UNITED STATES PATENT AND TRADEMARK OFFICE

APPLICATION NO.	FILING DATE	FIRST NAMED INVENTOR	ATTORNEY DOCKET NO.	CONFIRMATION NO.
10/088,470	08/21/2002	Tetsuya Takashima	MATS:036	2935

Office Action Summary

DETAILED ACTION

FIG. 4

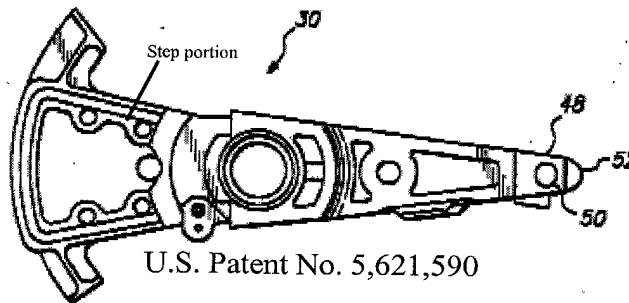
5. Claim 1-9 are rejected under 35 U.S.C. 103(a) as being unpatentable over Phillips et al. U.S. Patent No. 5,600,516 in view of Pace et al. U.S. Patent No. 5,621,590.

Referring to claims 1-10, Phillips disclose an actuator (72), comprising a pair of yokes (24) opposing to each other via a first specified space, a magnet (100) fixed to at least one of said yokes, and a carriage holding a coil on one end thereof against said magnet via a second specified space and rocking about a rotary shaft. wherein said carriage comprises two coil fitting arms (86) opposing to each other and at least one through-hole (104 and 106), piercing from bottom to top of said stepped portion, whose size is larger at the bottom than at the top (see fig. 6 and 6a), said coil disposed between said two coil fitting arms (86), and a holding member (90) for securing said coil fitting arms, said through-hole (104) and said coil. Also Phillips discloses and said step portion but doesn't disclose the two coil fitting arms having a step portion. However, Pace disclose a support coil member (34) having a step portion with holes for the purpose of supporting coil (32). Also disclose said through-hole (104) is formed at boundary portion between said coil fitting arm and the use of resin for encapsulation of the coil.

It would have been obvious to one having skill in the art at the time the invention was made to modify Philips' invention and made a step portion with through-hole and use resin for encapsulation of the coil for the purpose of support the coil as Pace disclose.
